Levy Nuclear Plant, Units 1 & 2

COL Application

Technical Specifications

PLANT SPECIFIC TECHNICAL SPECIFICATIONS (PSTS)

FIGURE 4.1-1 Low Population Zone and Site Boundary Map

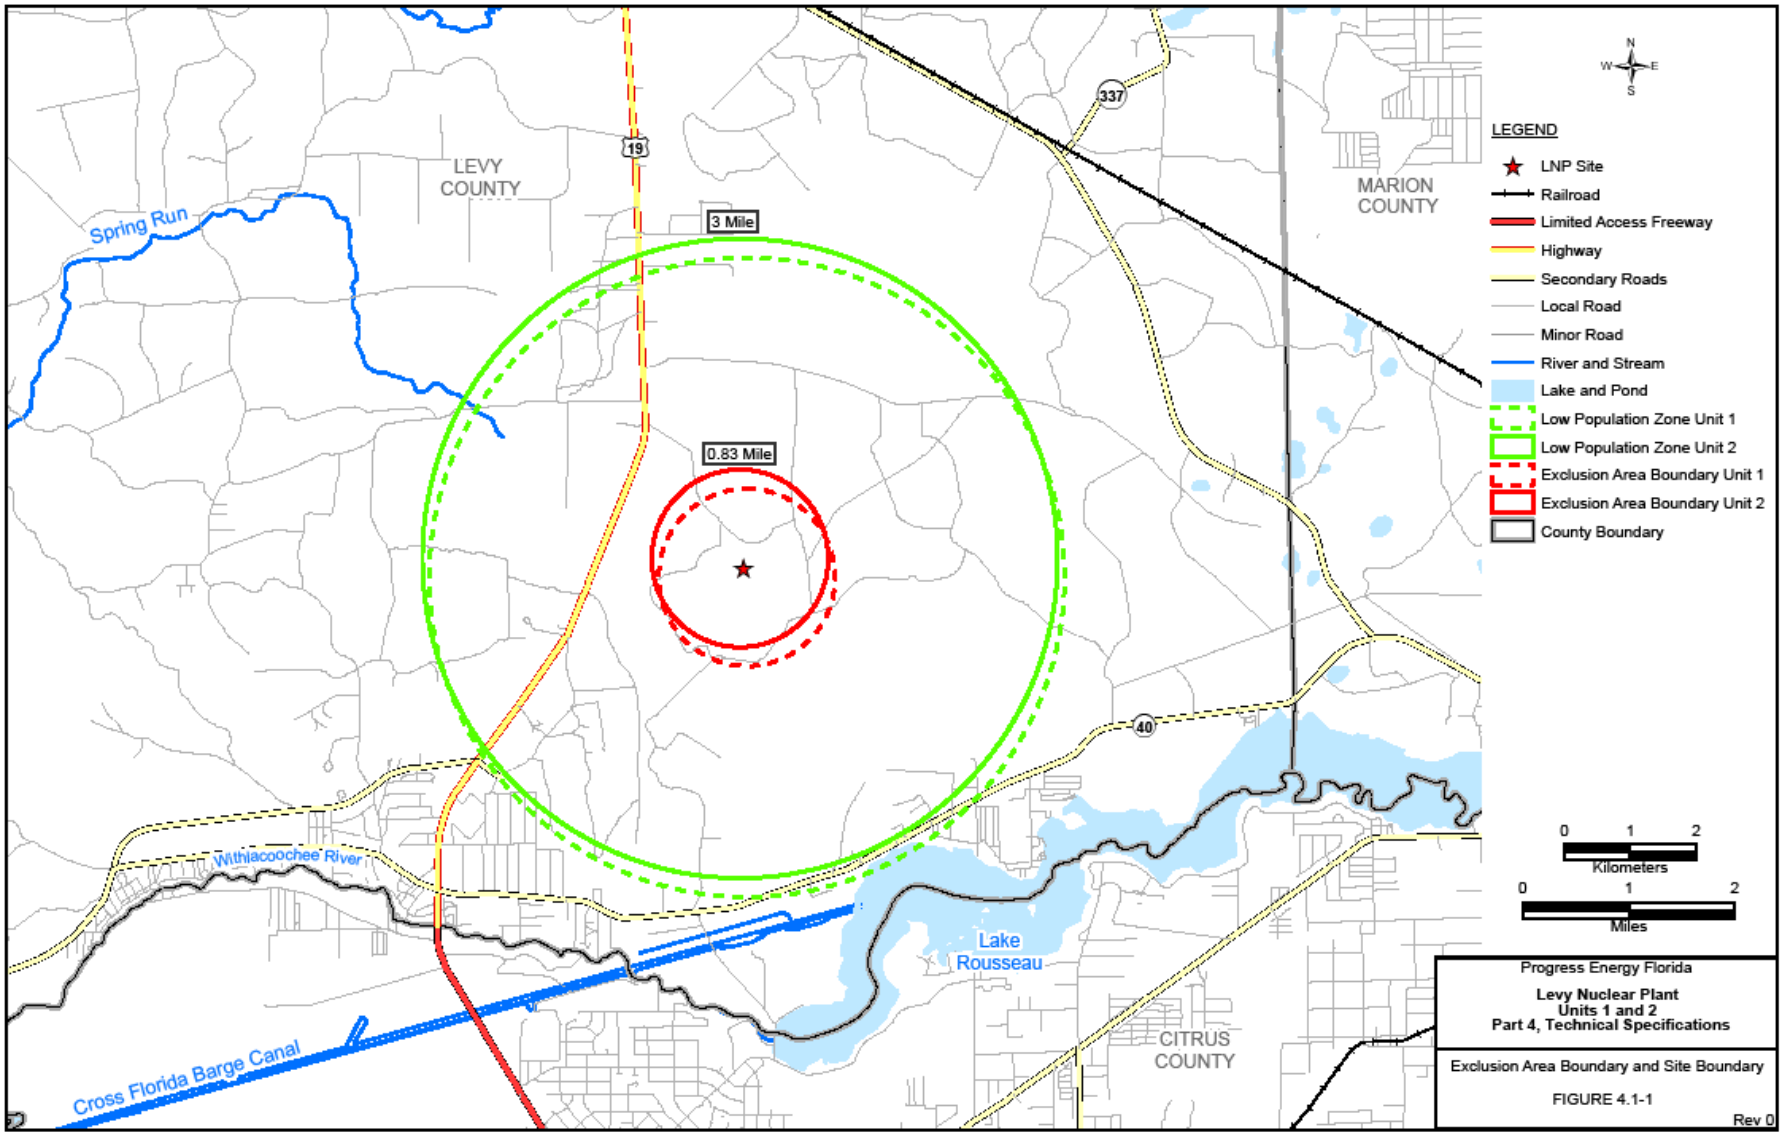
GTS 4.1.1 The bracketed information in the GTS reads:
[This information will be provided by the combined license applicant.]

The Site Boundary is shown in Figure 4.1-1.

Replace the bracketed information in the GTS with the following:
The LPZ is defined by the 3 mile radius from the site center point as shown in Figure 4.1-1.

Justification
Bracketed information is replaced to establish Site Boundary and Exclusion Area Boundary for LNP consistent with the descriptions identified in FSAR Sections 2.1.1.2 and 2.1.1.3.

FIGURE 4.1-2 Exclusion Area Boundary

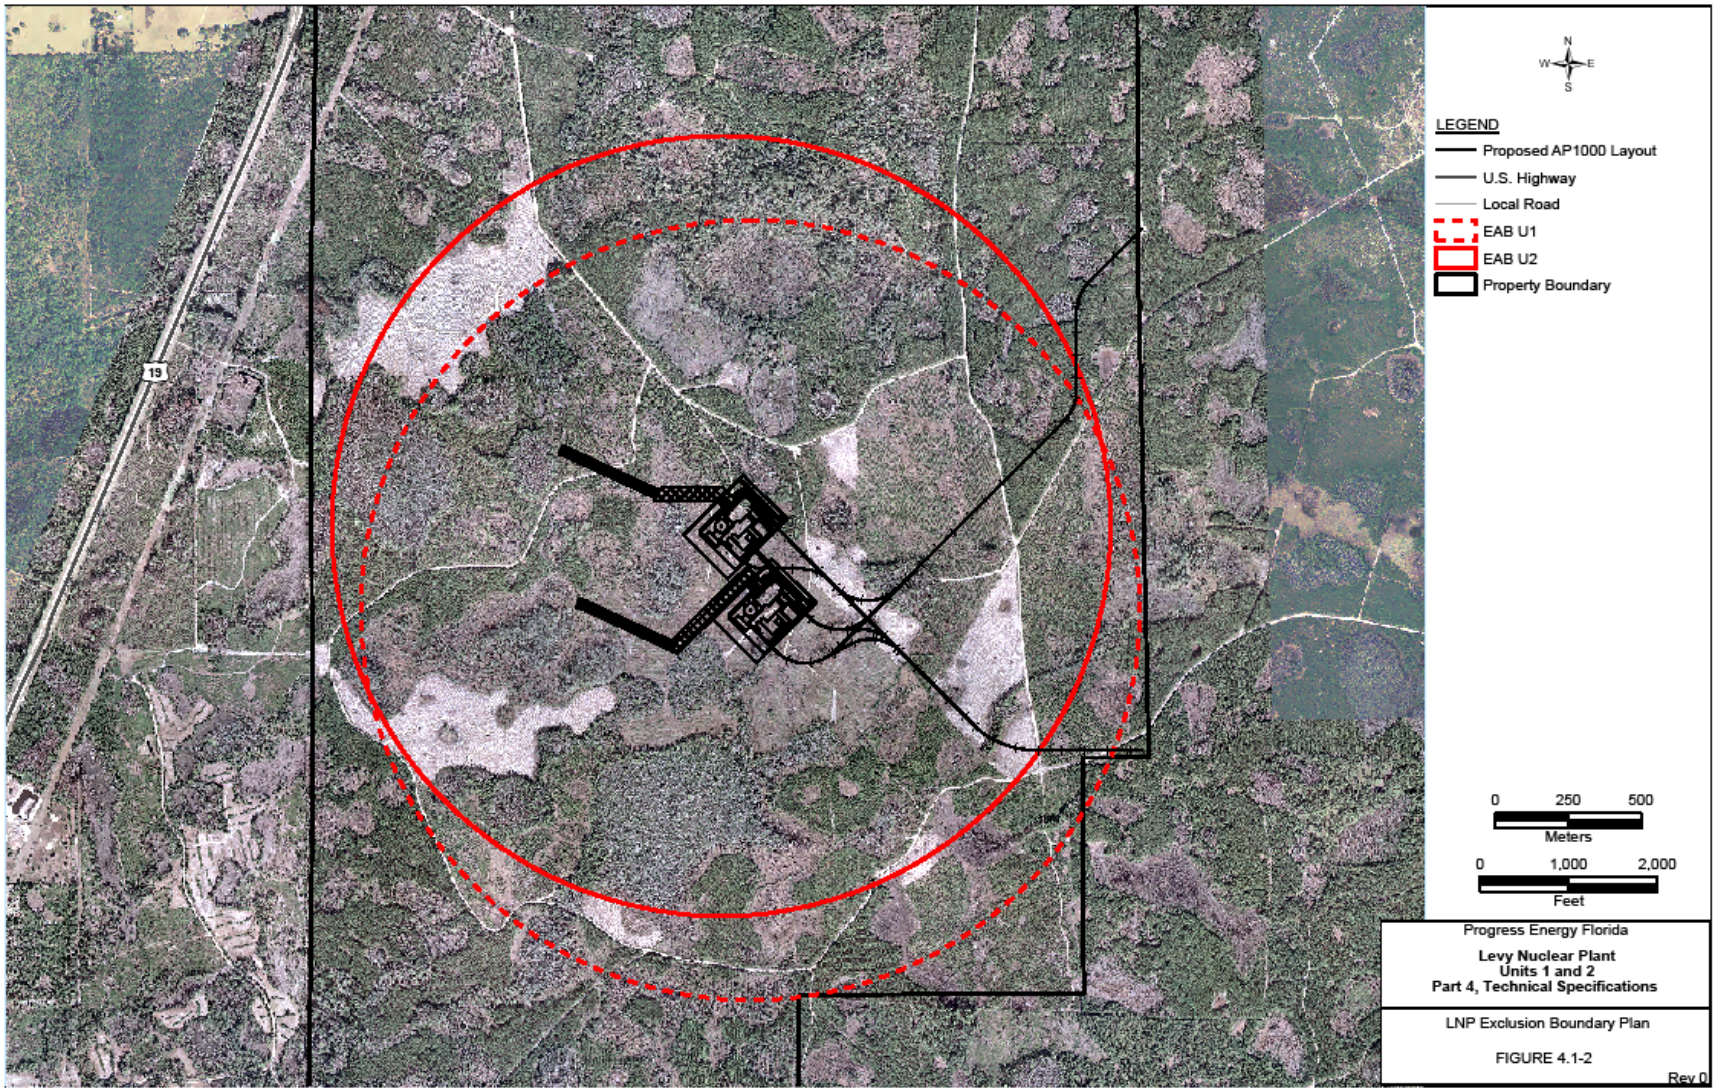
The Exclusion Area Boundary is shown in Figure 4.1-2.
